Re: 1020 East Cooper Project Restudy

Thank you for the constructive feedback during the January 13, 2021 HPC hearing. We have restudied the project to incorporate your comments, bring forth a Land Use Code compliant project, and maintain much needed local workforce housing. This is a consolidated application as permitted in the Land Use Code to streamline the review process. As such, HPC is asked to balance not just the Historic Preservation Design Guidelines but other important aspects of the Land Use Code including Growth Management and Affordable Housing Credit Certificates to name a few. The restudy is summarized below and addressed in the attached Exhibits.

Figure 2: West Elevation revised, January 27, 2021. Height of alley building is reduced, the third floor mass is reduced and setback from the south, east, and north elevations.

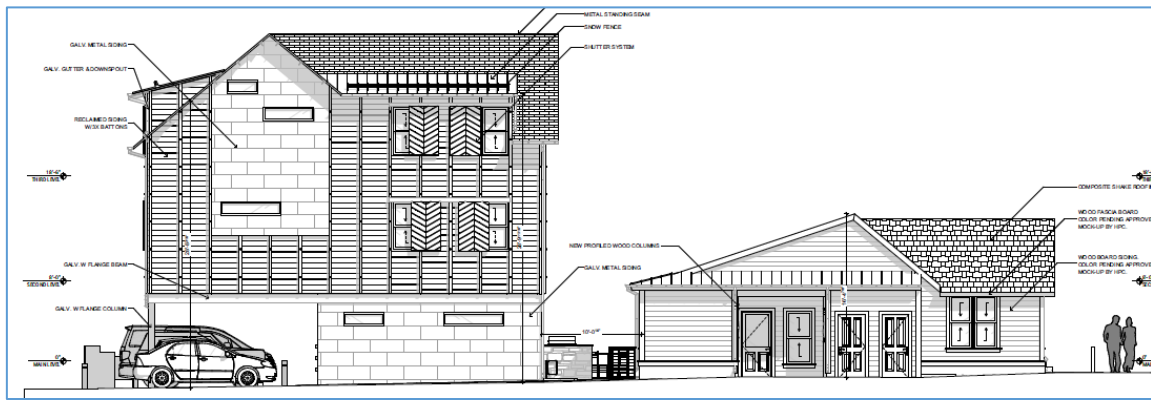
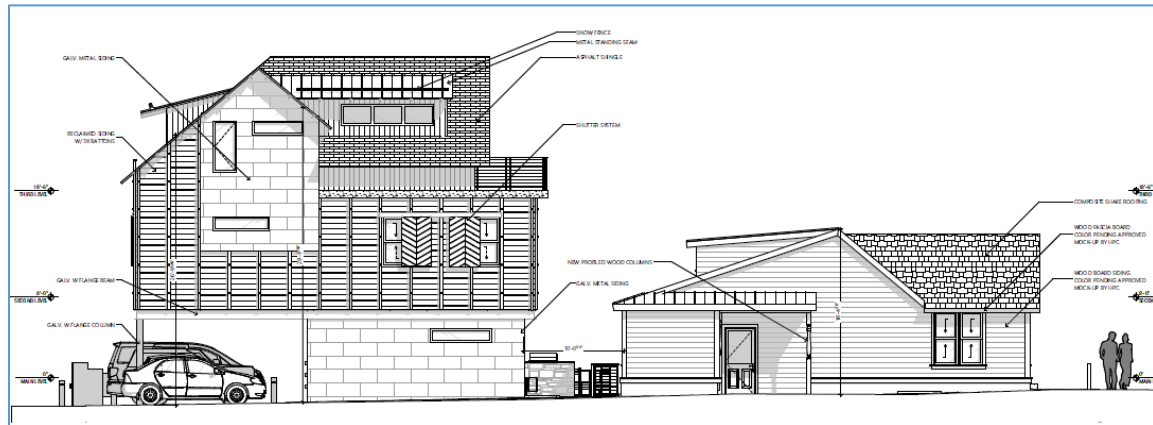
The mass, scale and height of the detached rear building has been reduced to better relate to the historic resource. Floor area has been reduced from 4,277.2sf (December application) to 4,241sf (January application) to 3,899.5sf (February “current” application). The three bedroom unit proposed on the third floor has been relocated to the rear unit in the landmark and replaced with a two bedroom unit. Dormers are proposed on the non-historic roof to add a full height bedroom within the existing landmark footprint. The dormers are pulled in from the sides of the landmark, do not conflict with the cross gable roof form, and are hidden from street view in compliance with Guideline 7.6.

The third floor massing is significantly stepped back from the south elevation to read as a two story building (Guidelines 11.3, 11.4, 11.6, 11.7). A large deck faces Aspen Mountain to provide private outdoor space for the two bedroom unit and to accommodate for a unit size reduction within APCHA parameters. The gable roof is brought down to the second level and dormers are added to further reduce mass and scale of the third story (Guideline 11.3, 11.4, 11.6, 11.7). Exterior storage for the second and third levels (Units 201 and 301) is removed to reduce mass and scale.

Height has been reduced 2 feet on the east/west ridge and 1 foot on the north/south ridge. Proposed height is well below the maximum 32 feet in the Zone District – the south elevation is 27ft. 6 in and the north elevation is 26ft. 8.5 in. Reducing height strengthens the relationship between the landmark and the detached alley building and conforms to Guidelines 11.3, 11.4 and 11.6.

Figure 2&3: Comparison of third floor plan changes: plan at left was presented in January, and plan at right is revised proposal.

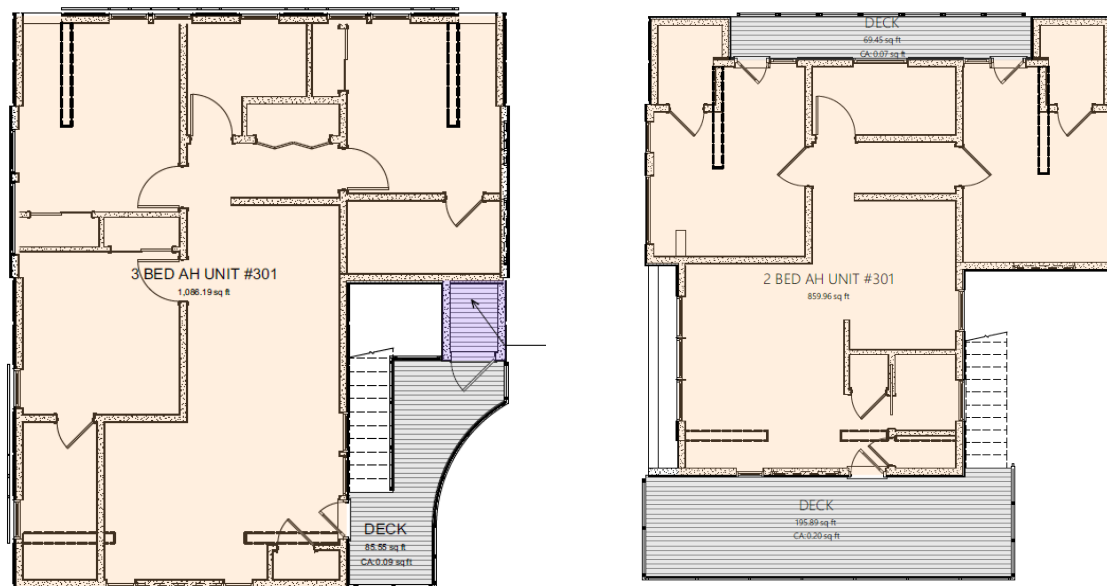
Response – The proposed L shaped footprint of the new building directly references the historic building’s footprint. The prominent gable roof form has a similar pitch to the historic building. Material changes and facade setbacks between the second level and third level breaks up the massing into smaller modules that relate to the historic building. The third floor unit has been significantly reduced from a 1,086.2sf unit to a 789.52sf unit, and is setback from the north, east and south facades to reduce mass and scale. The height of the north-south ridge has been reduced by ~1 foot and the height of the east-west ridge has been reduced by ~2 feet.

Figures 4 & 5: Comparison of January 13, 2021 south elevation to February 10, 2021 revised elevation.

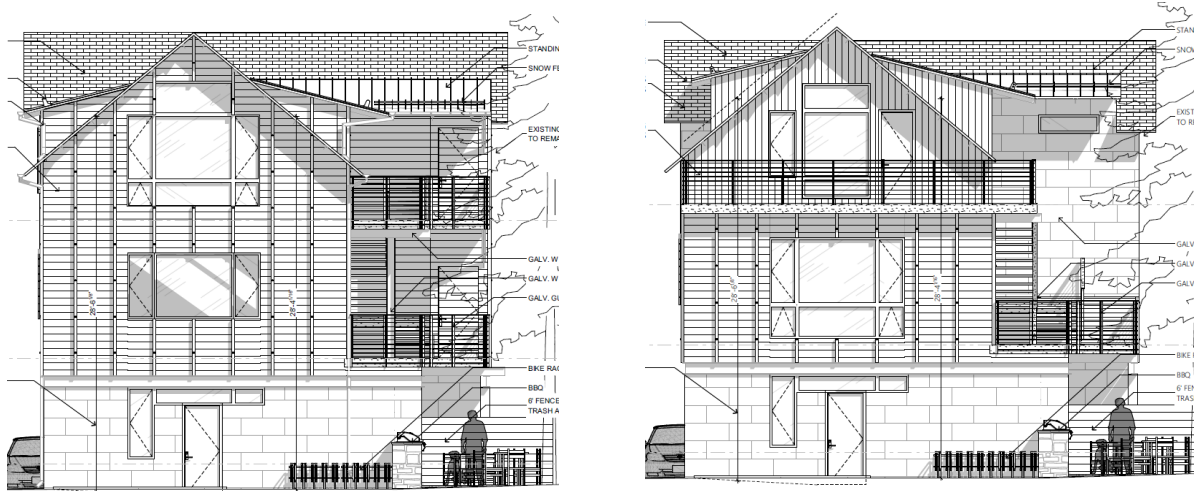
Decks and open stairs are proposed behind the landmark to break up the mass and to provide relief to the Riverside Condominiums. Exterior storage units on the second and third floor have been removed to further reduce the south and east facades as shown below.
